Work Order ID 77535

Item Name: Crosstube Fwd

DART AEROSPACE LTD		Work Order:	77535
Description: Crosstube High Fwd (205/212/412)		Part Number:	D212-664-101
Inspection Dwg: D212-664-141	Rev: D	Page 1 of 1

DRAWING NO. D212-664-141	TITLE XTUBE ASSY (205/212/412 HI FWD)	REV. D	DART AEROSPACE LTD ENGINEERING ORDER		D.E.O. NO. D212-664-141-D-1	SHEET NO. SHEET 1 OF 2	SCALE NTS
DRAWN	CHECKED	MFG. APPR.	APPROVED	DE APPR.			
DATE 11.04.07	DATE 11.04.11	DATE 11.04.12	DATE 11/04/12	DATE 11.04.12

**D212-664-141/-141B
ASSEMBLY DETAIL**

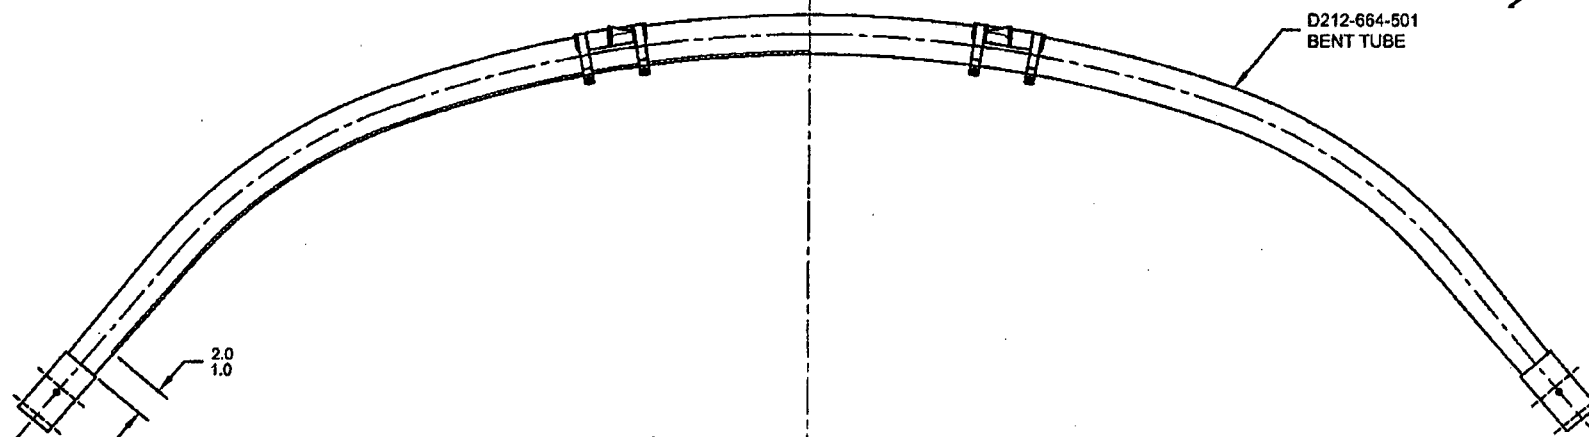
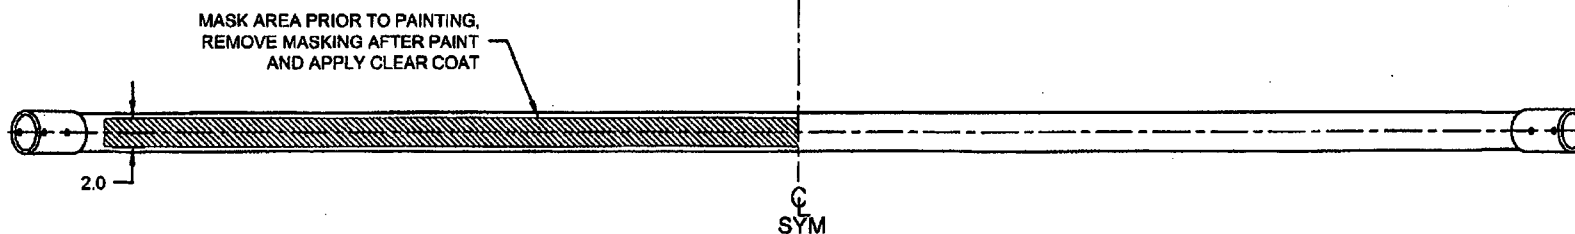
PURPOSE:

ADD AN INSPECTION WINDOW TO UNDERSIDE OF CROSSTUBE.

NOTES 2 OF SHEET 1 IS AMENDED AS FOLLOWS:

- 2) FINISH: CHEMICAL CONVERSION COAT PER DART QSI 005 4.1
PRIME INSIDE AND OUTSIDE PER DART QSI 005 4.2
MASK UNDERSIDE OF CROSSTUBE AS SHOWN (HATCHED AREA) AND
PAINT OUTSIDE PER DART QSI 005 4.2
REMOVE MASKING AND APPLY CLEAR COAT

- 2) FINISH: CHEMICAL CONVERSION COAT PER DART QSI 005 4.1
PRIME INSIDE AND OUTSIDE PER DART QSI 005 4.2
PAINT OUTSIDE PER DART QSI 005 4.2
